GMU Project 17-206-02
Permit No. PKG21-0490

Subject: Response to County of Orange Geotechnical Review Comments Pertaining to Precise Grading Plans, Dana Point Harbor Revitalization, Buildings 1 through 12, Commercial Component, City of Dana Point, California

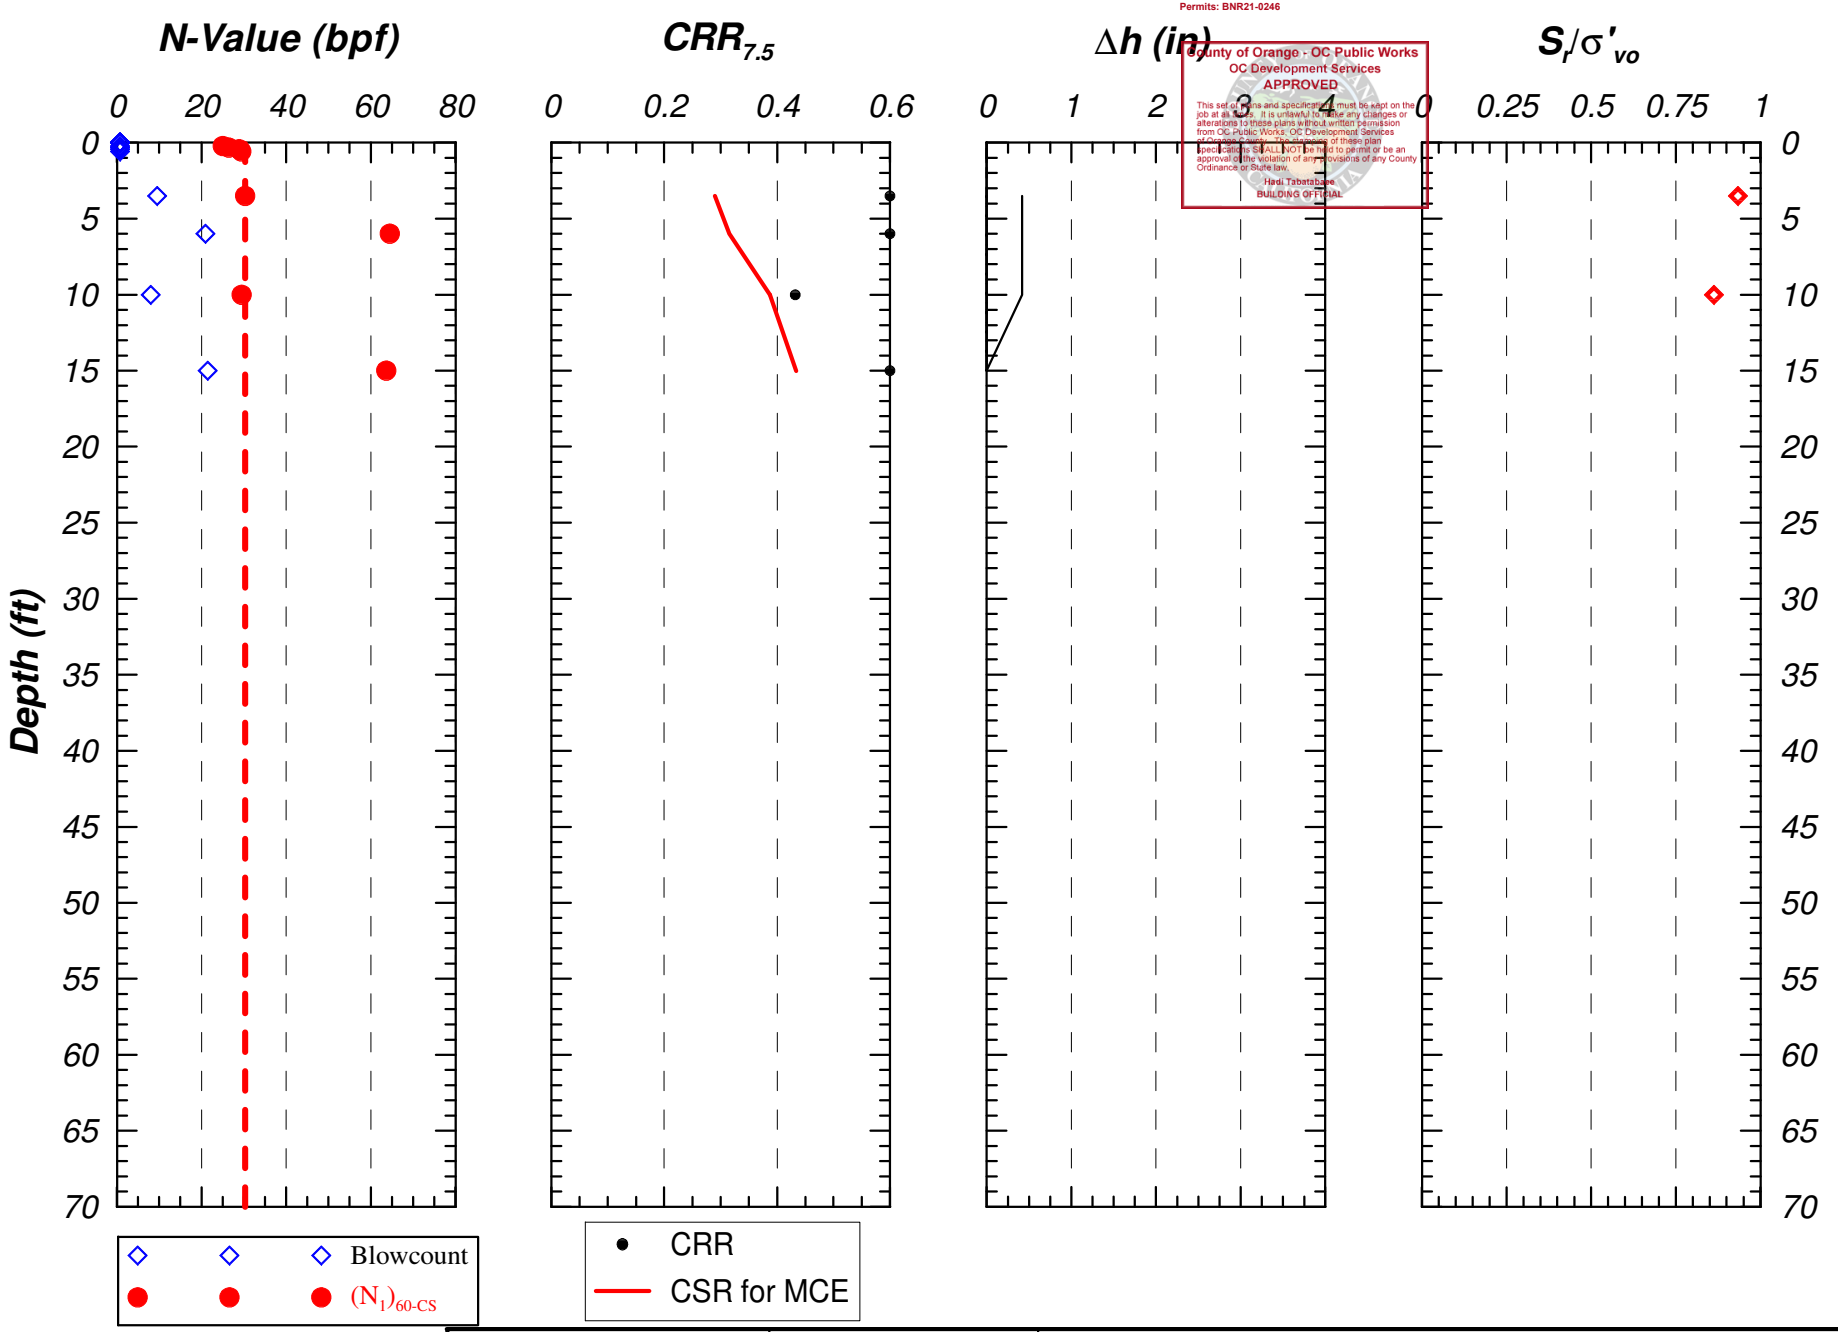
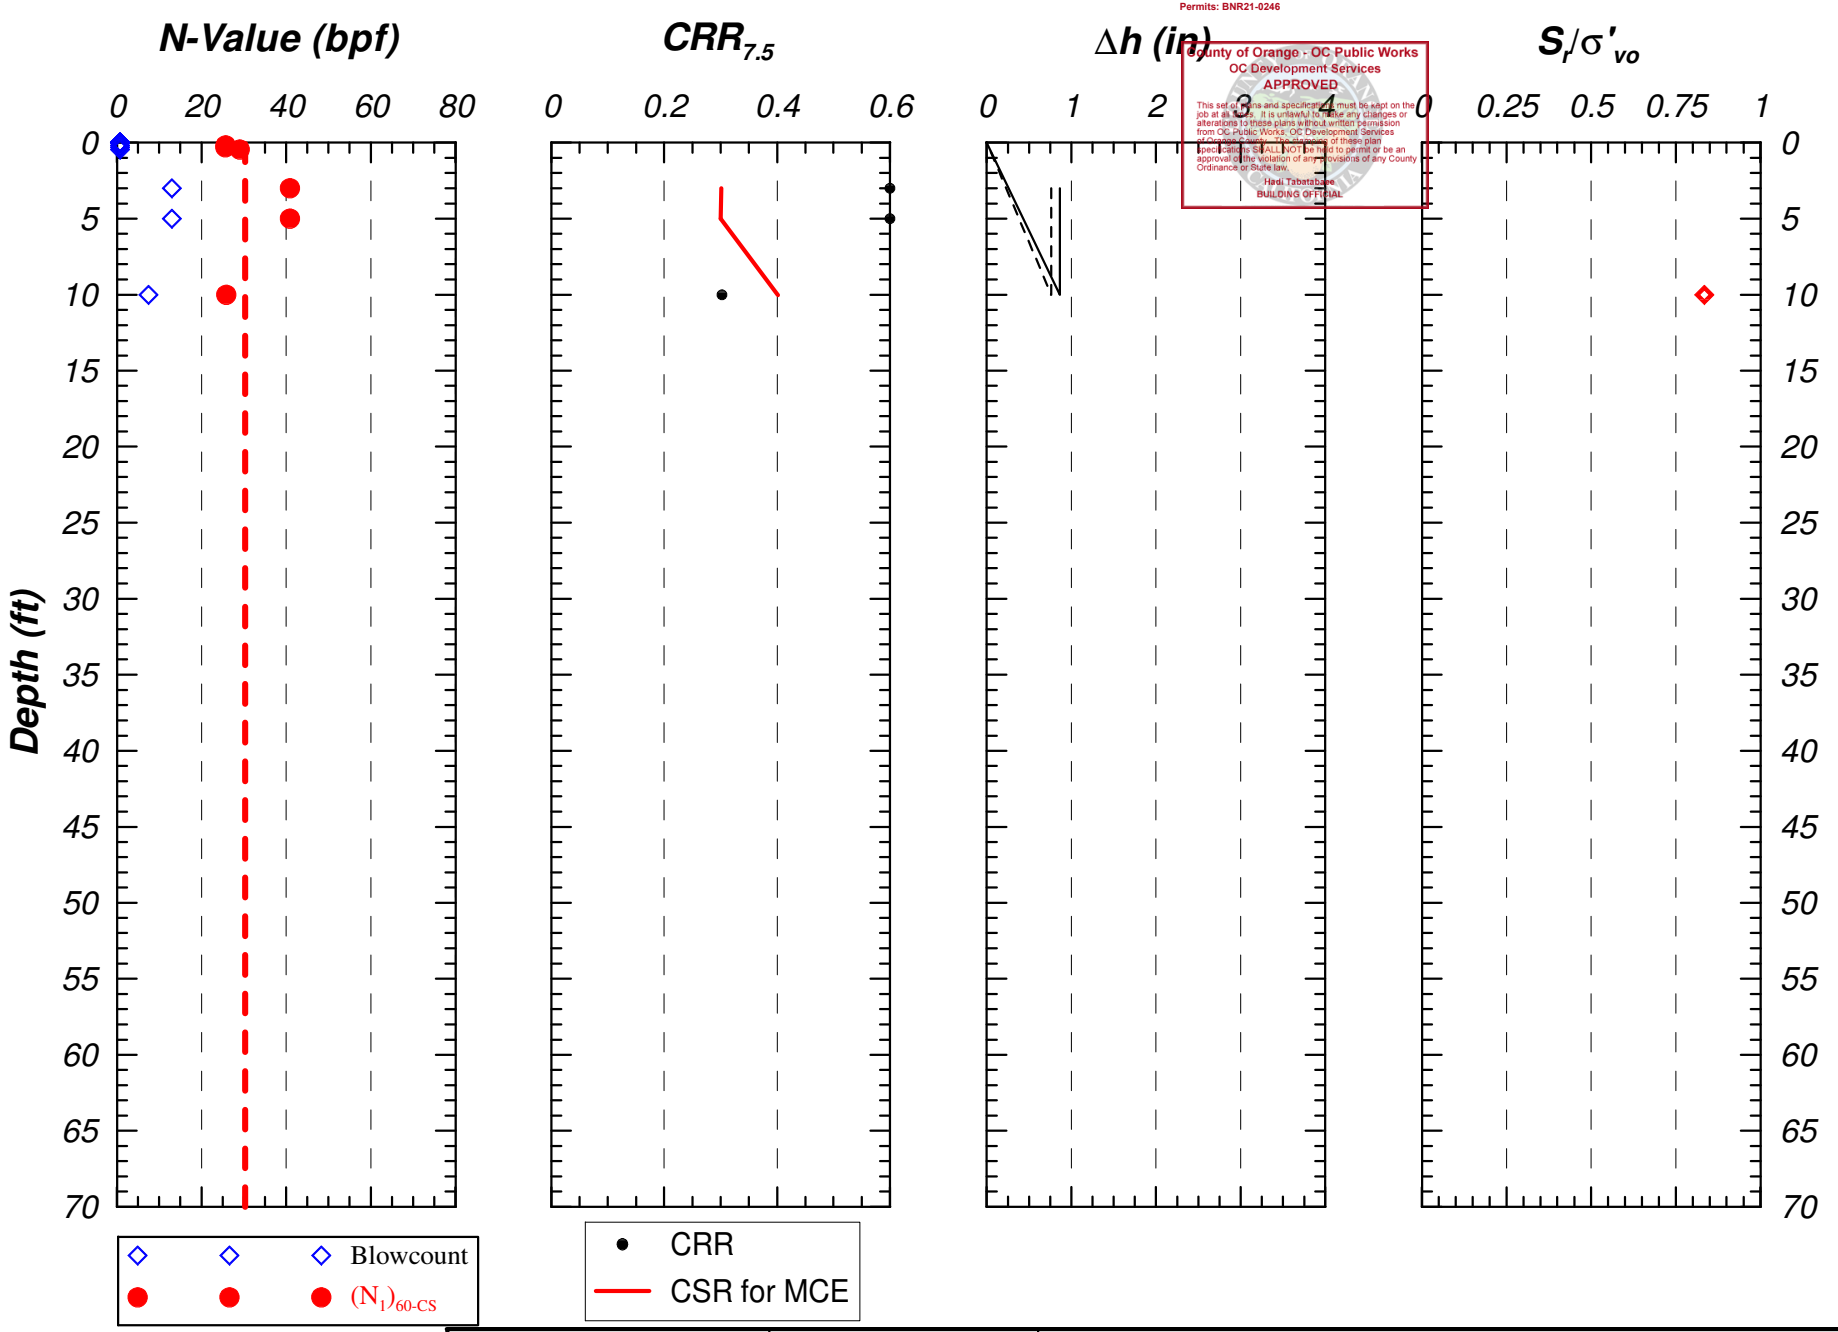
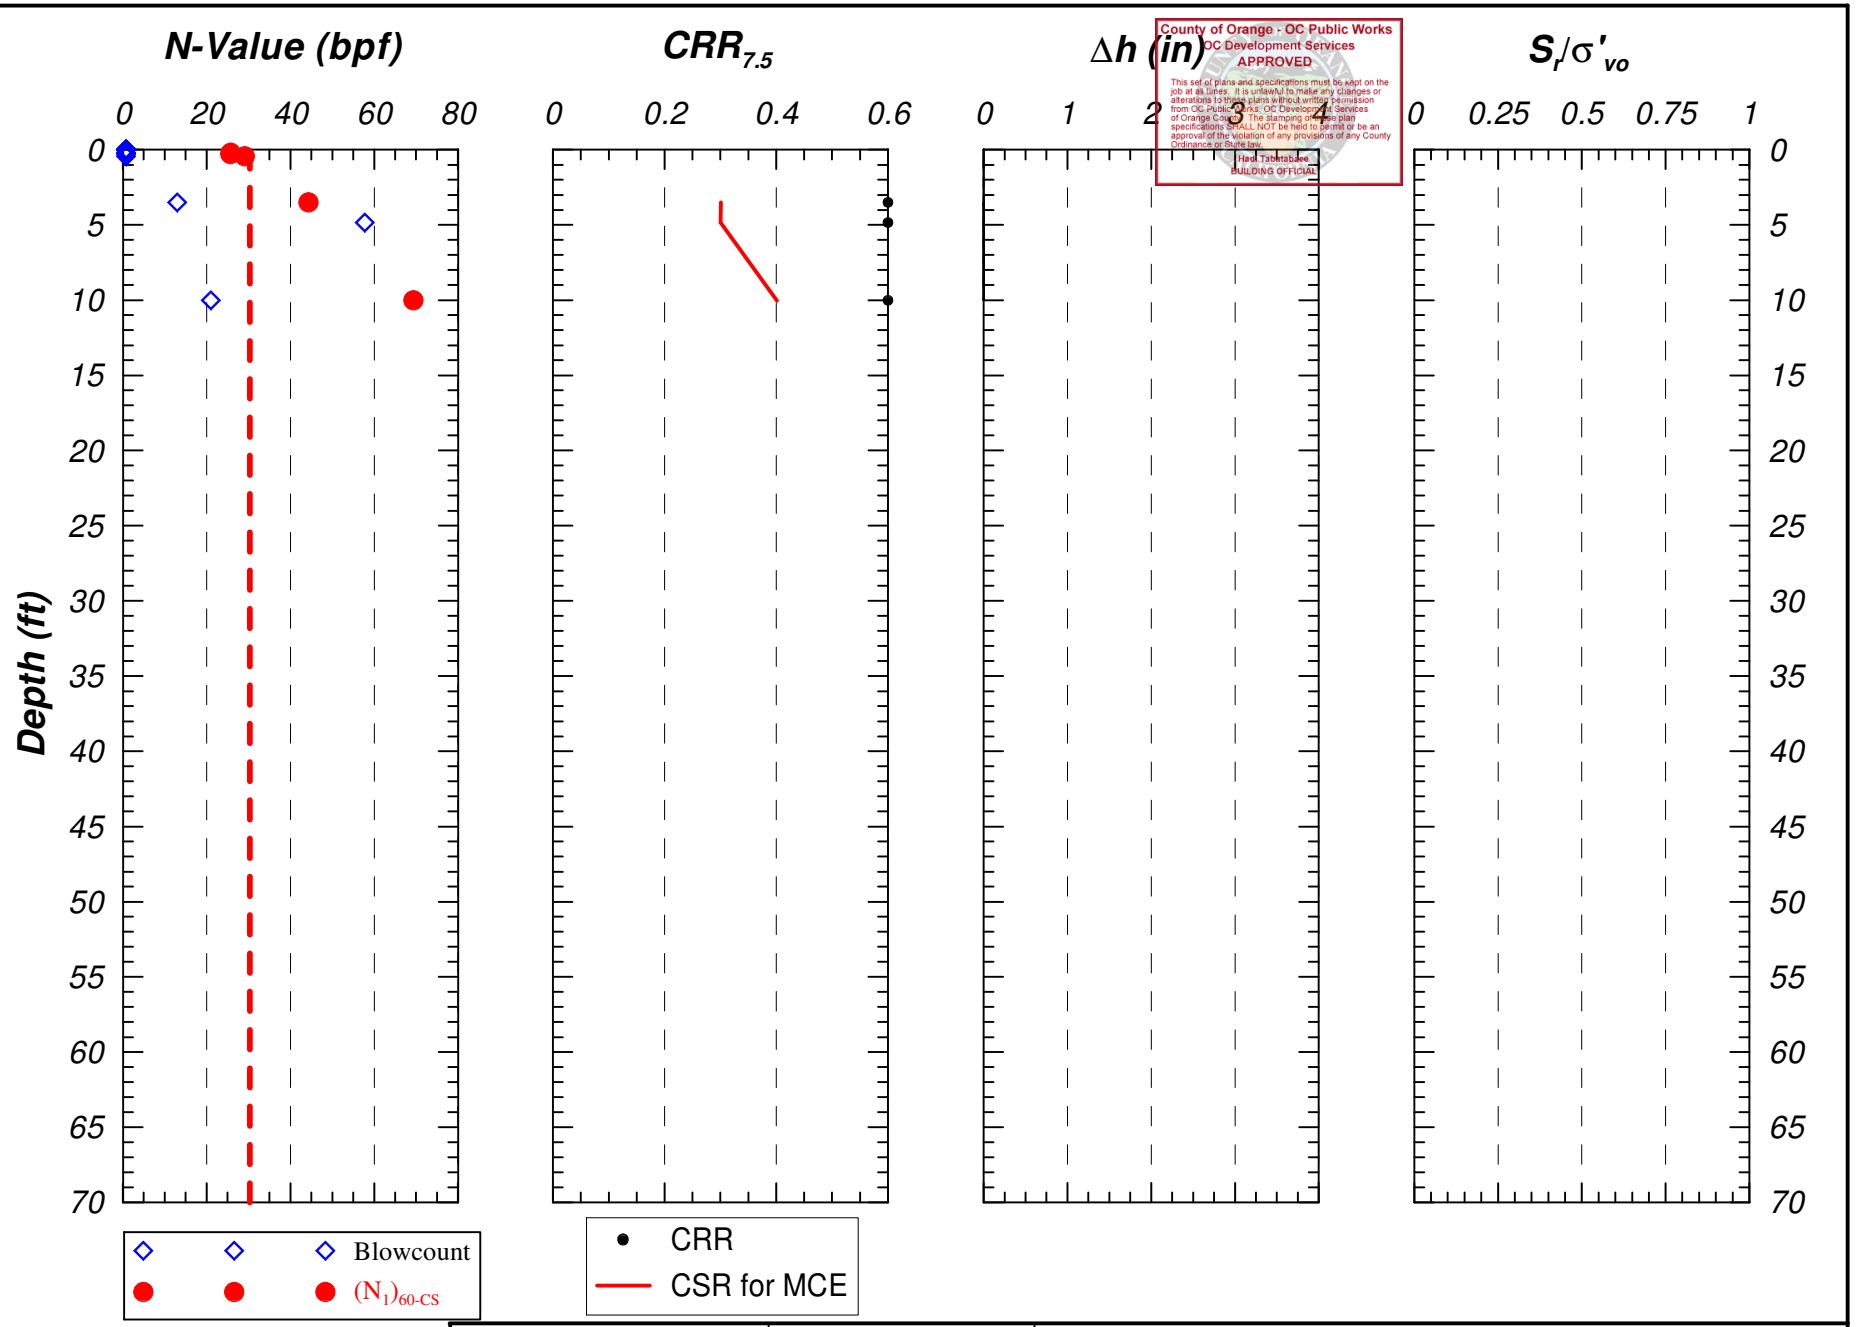
The submitted geotechnical report (GMU Geotechnical, Inc., dated 5/27/21) indicates that liquefaction analysis was performed on the SPT exploratory data as a cross-check to the CPT liquefaction analysis and yielded similar results. Please provide a copy of the completed SPT liquefaction analysis as discussed in the submitted report. Provide additional recommendations as needed.

Results of the liquefaction analysis performed on SPT data of six (6) exploratory borings (DH-12, DH-17, DH-18, DH-19, DH-26, DH-51) are included as Appendix B. As stated in the submitted geotechnical report, CPT-based liquefaction analyses provide a more reliable, accurate and continuous database from which to calculate liquefaction magnitude. The SPT-based analysis was generally consistent with the results of the CPT-based analysis, but it does include a few isolated cases indicating a larger magnitude of settlement, which is not uncommon using SPT-based analysis. We do not believe these aberrations are accurate predictions of the expected earthquake-induced settlements under the considered ground motions.
